## SERVICE INFORMATION NO. SI 20-045

FAA Airworthiness Directive No 2011-14-09  
ATA-Code: 74 - Ignition

**Airworthiness Directives; Various Aircraft Equipped With Rotax Aircraft Engines 912 A  
Series Engine**

## REPLACEMENT OF WASHER PART NO. 944072 (FLY WHEEL HUB) FOR ROTAX® ENGINE TYPE 912 AND 914 (SERIES)

Fig. 1

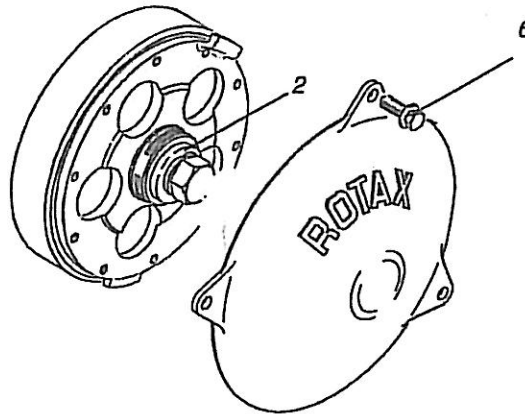
See fig. 1.

1. Remove ignition cover (1).
2. Lock the crankshaft in accordance with the relevant Maintenance Manual (Line).
3. Remove hex. screw (4) in accordance with the relevant Maintenance Manual (Heavy).

■ CAUTION: If the fly wheel hub has loosened during the disassembly and/or in case of doubt, then remove, clean and install the fly wheel hub in accordance with the relevant Maintenance Manual. In this case the tightening torque is 45 Nm (33.2 ft.lb) + 180° angle to rotation.

4. Install hex. screw (4). Tightening torque 120 Nm (89 ft.lb).

■ CAUTION: During installation the new washer (2) part no. 944072 must be used.

5. Remove locking pin of crankshaft in accordance with the relevant Maintenance Manual.
6. Check trigger coil gap, if necessary adjust it in accordance with the relevant Maintenance Manual.
7. Install ignition cover (1). The hex. screws (6) are locked with Loctite 221. Tightening torque 5 Nm (44 in. lb.).
